Building Permit Application

Amendment, Permit # B 16004872

I am requesting to amend Permit # B16004872 at
17245 HARDY ROAD MT. AIRY 21771 to
CONSTRUCT A DETACHED 2 CAR GARAGE
PER ATTACHED PLAN.

SANDERS RESIDENCE

FINISHED BASEMENT PLAN

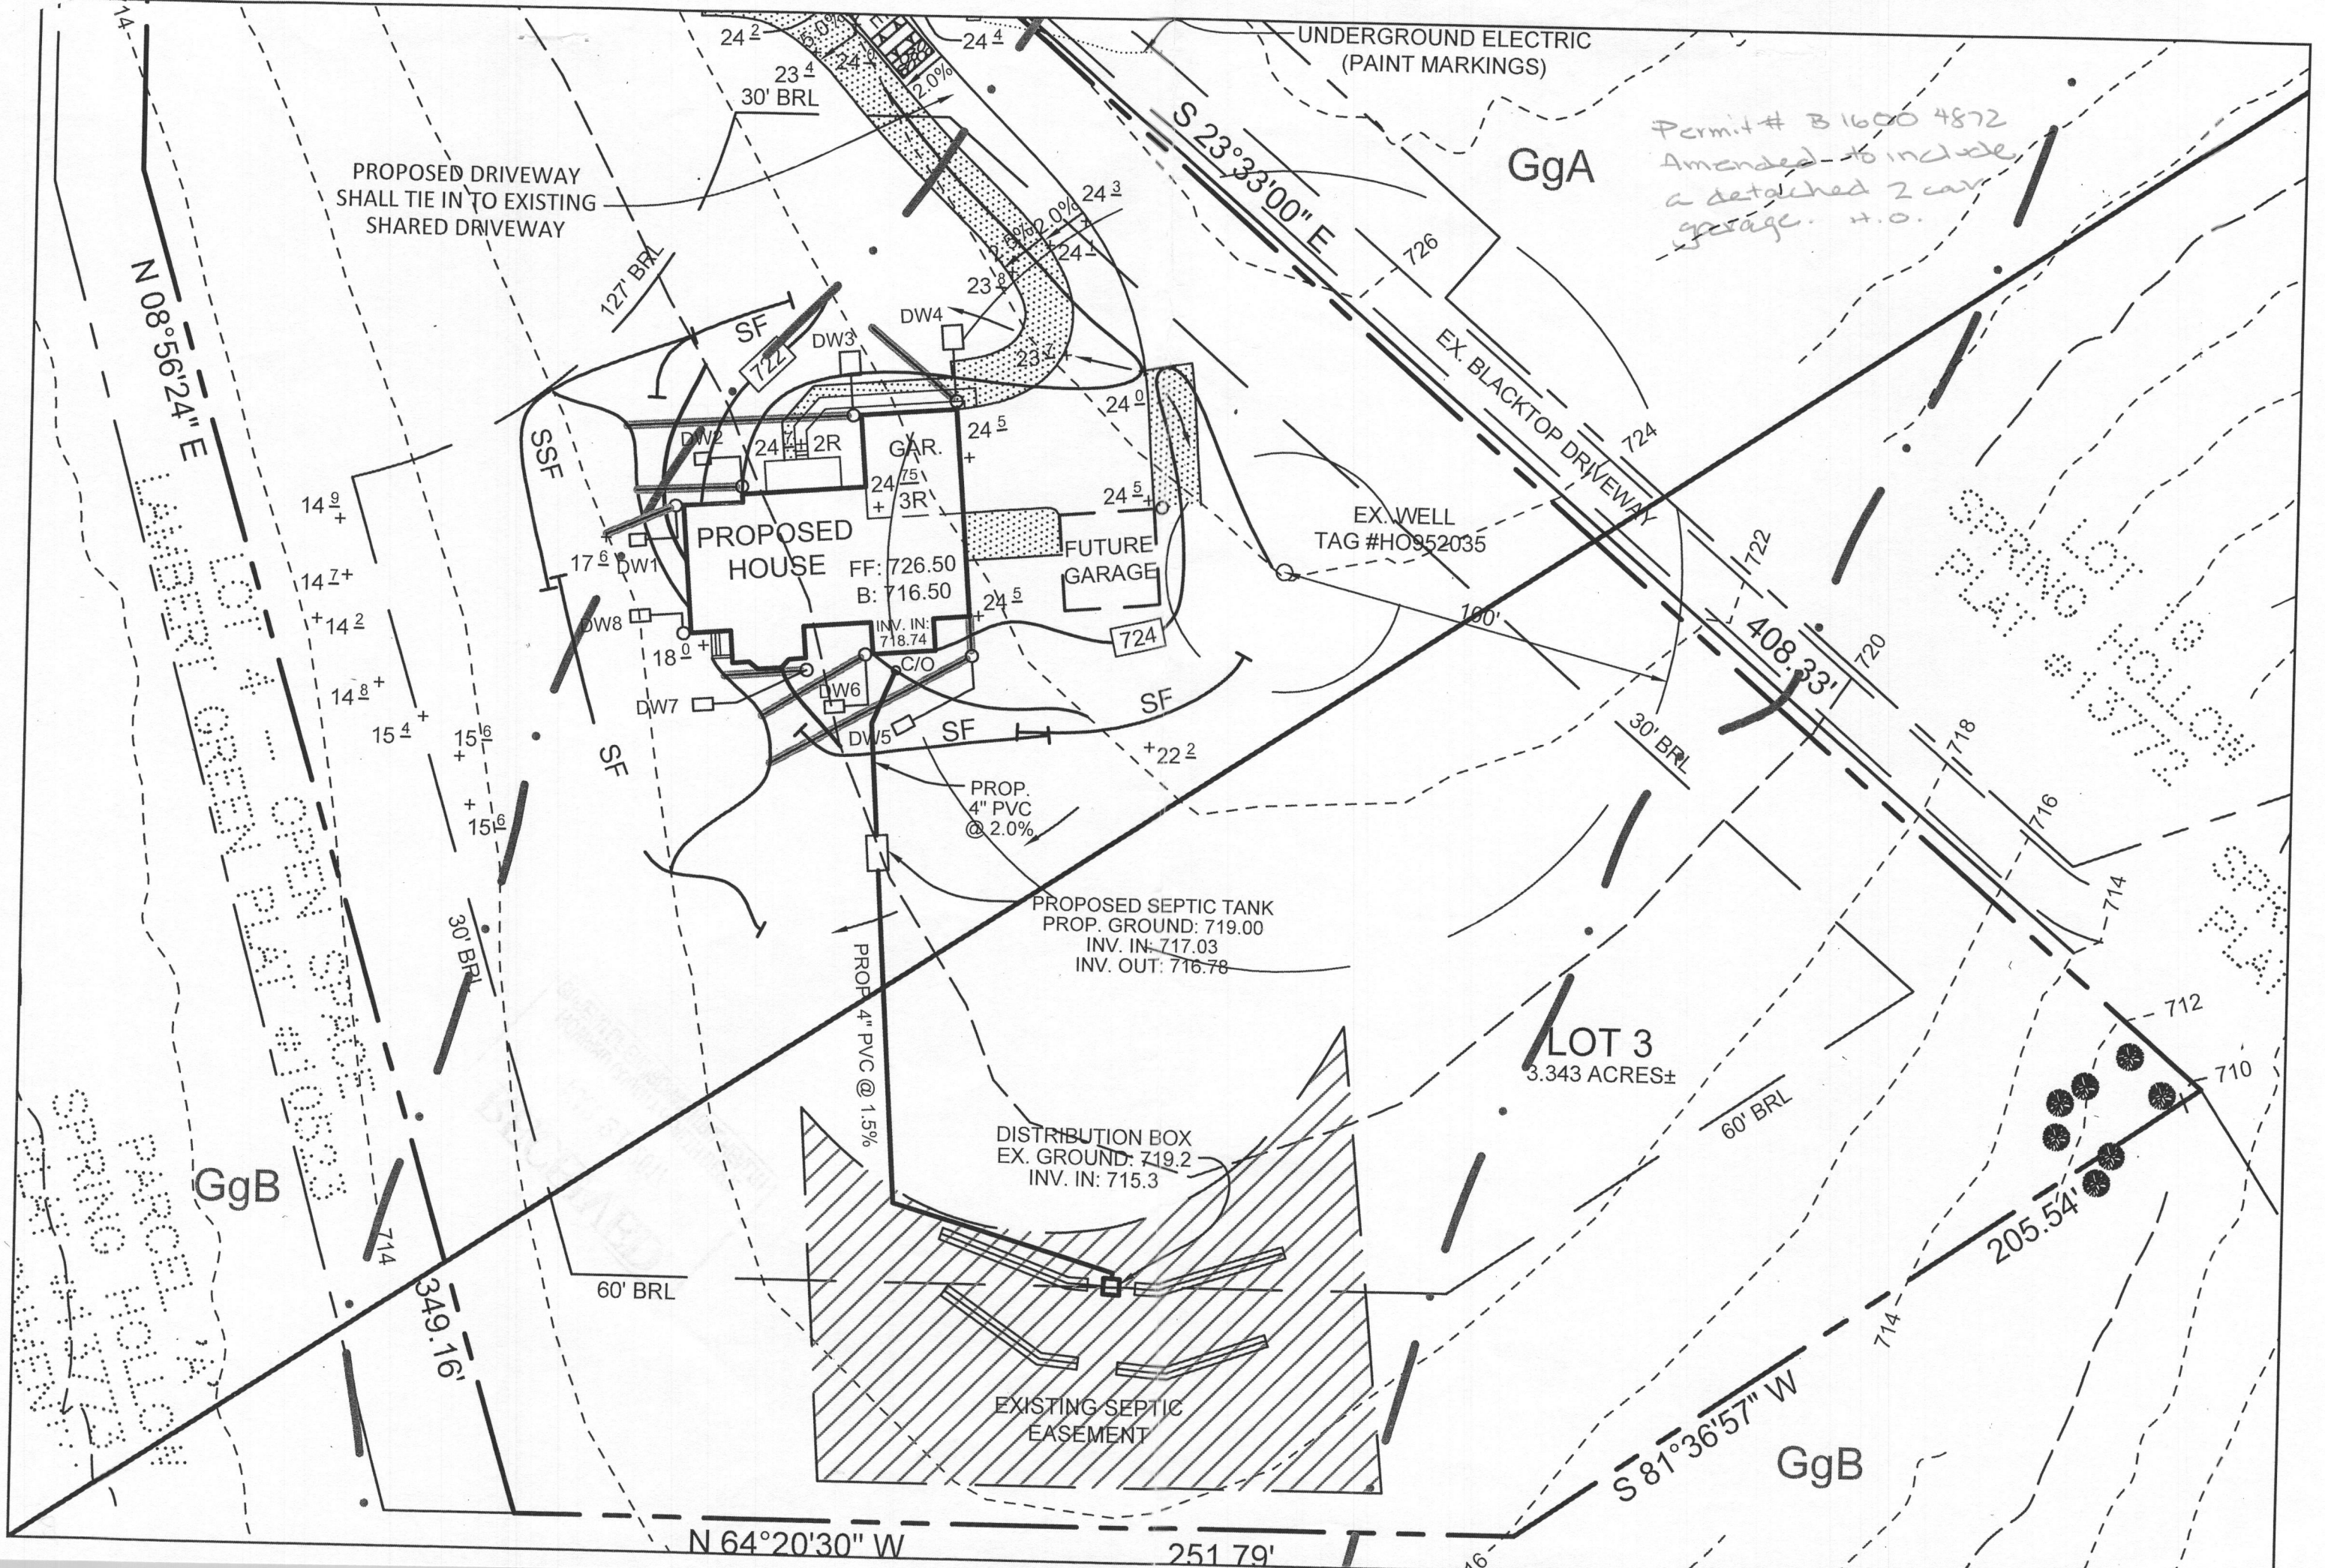
I am requesting to amend Permit # B 16 00 48 72 at
WE WANT TO ADD A FINISHED BASEMENT to
THE SINGLE FAMILY DETACHED. THE HOUSE IS
CURRENTLY UNDER CONSTRUCTION AND WILL BE BUILT
OUT SIMULTANEOUSLY
REC ROOM, BATH, BEDROOM #3, EXERCISE + UNFINISHED
Rev #2 3/21/2017 JB

APPROVED
 WALK-THRU BUILDING PERMIT
 BP# 11600487 A# Amendment
 APP. SAN H. Oswald DATE: 3/2/17
 DESC. OF WORK: Finish basement
to include rec. room, bedroom
full bath & exercise room.

LEFT ELEVATION

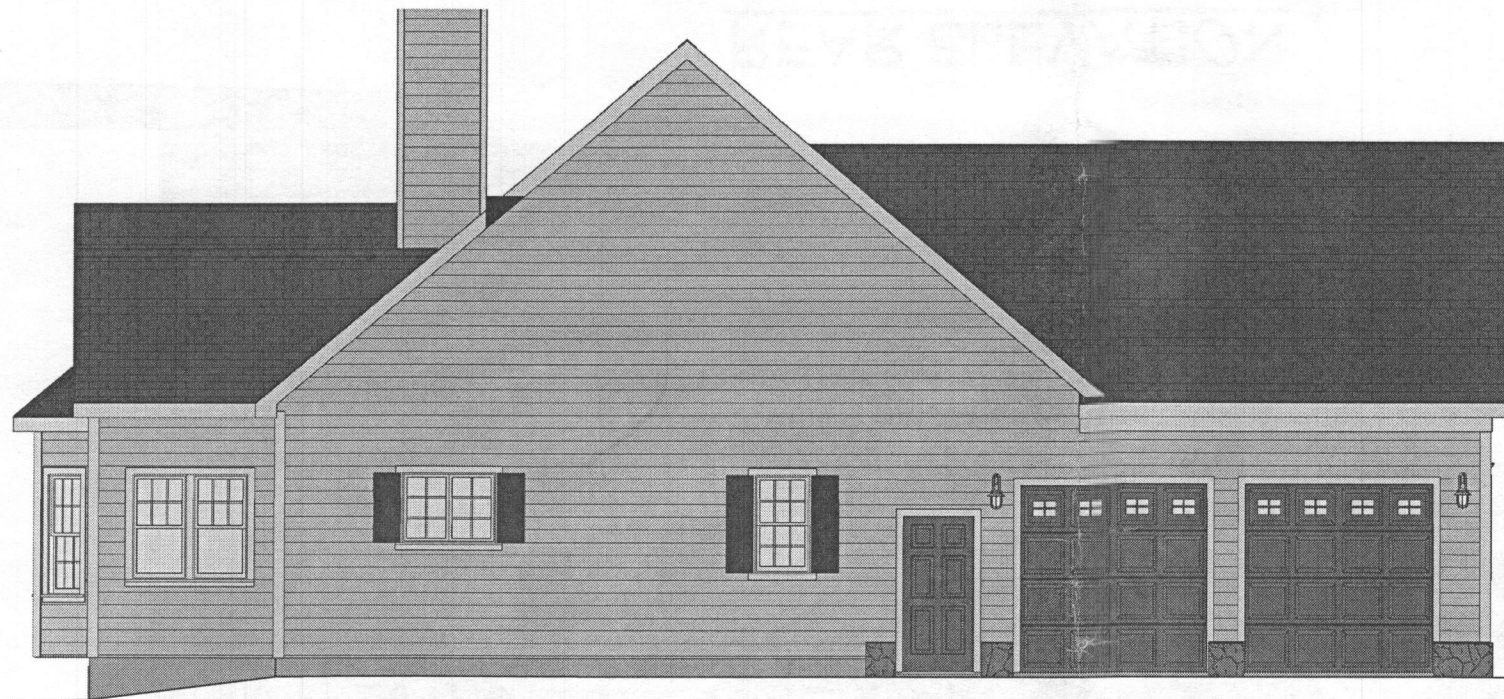
I have quick question about the floor plans for 17245 Hardy Road. Is there a second floor?

There is no 2nd floor
This is a ranch style home

PLOT PLAN
SANDERS PROPERTY
 LOT 3
 LAMBERT GREEN

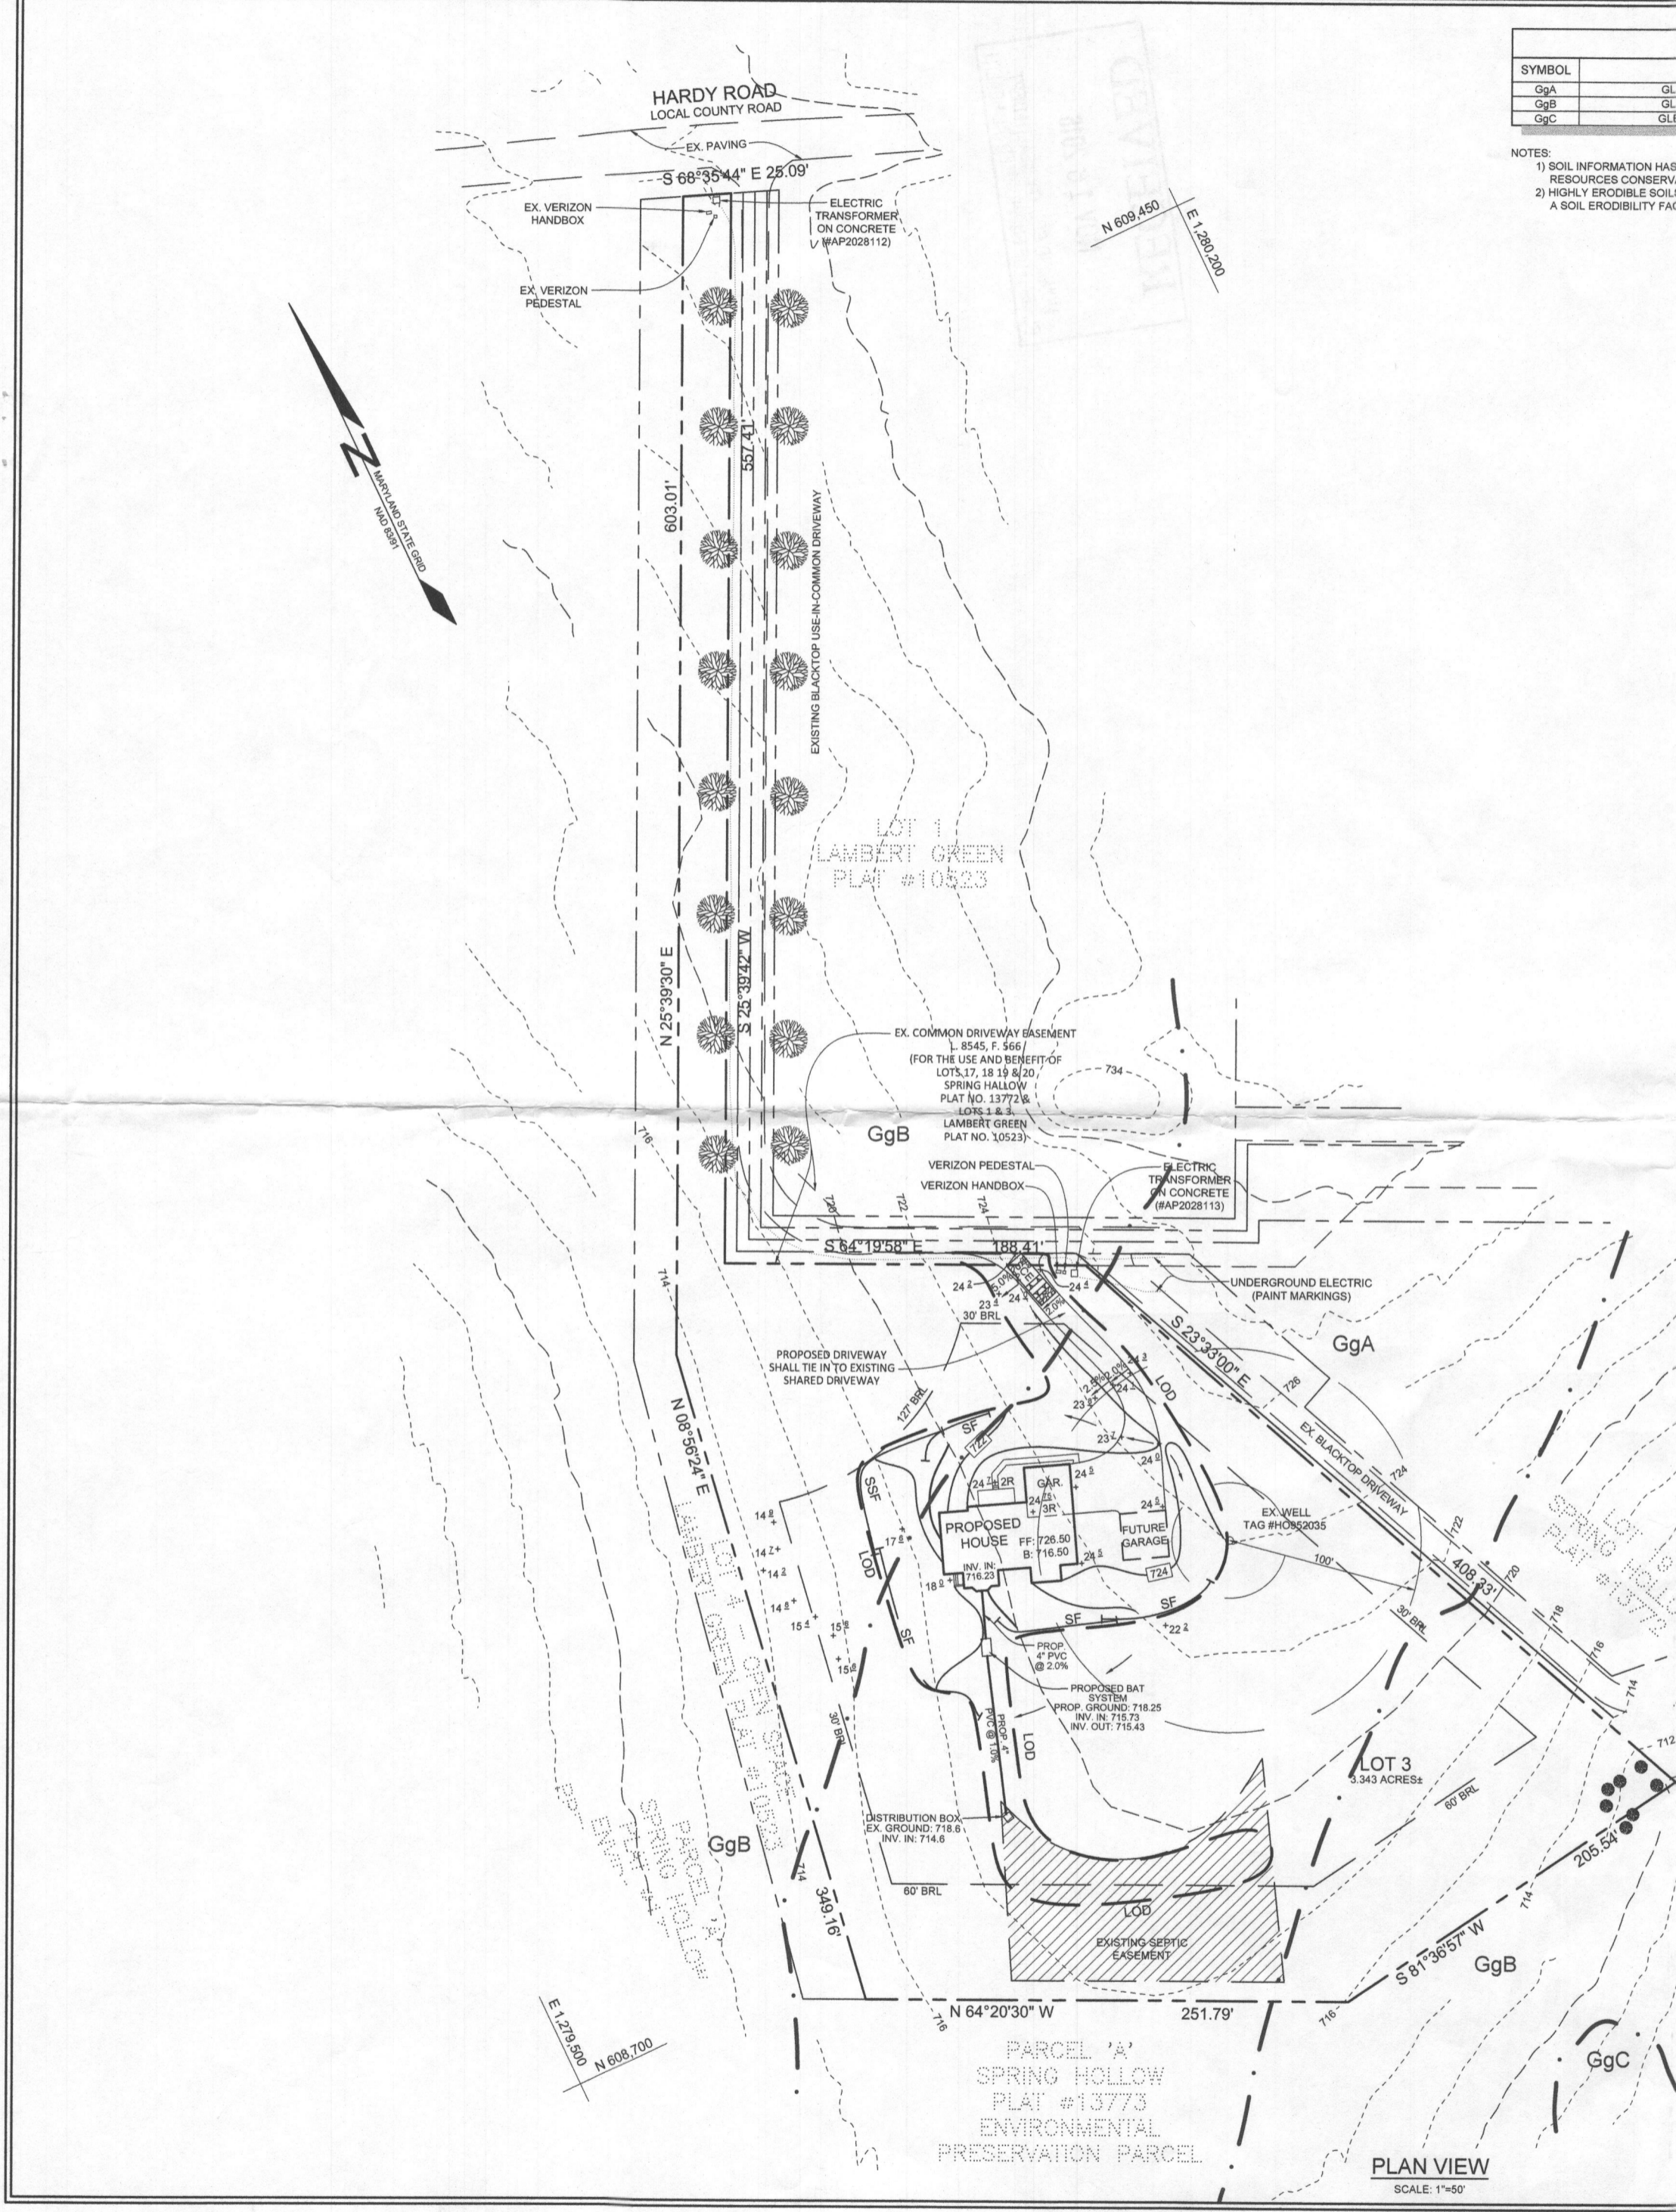
Permit # B1600 4872
Amended to include
a detached 2 car
garage. H.O.
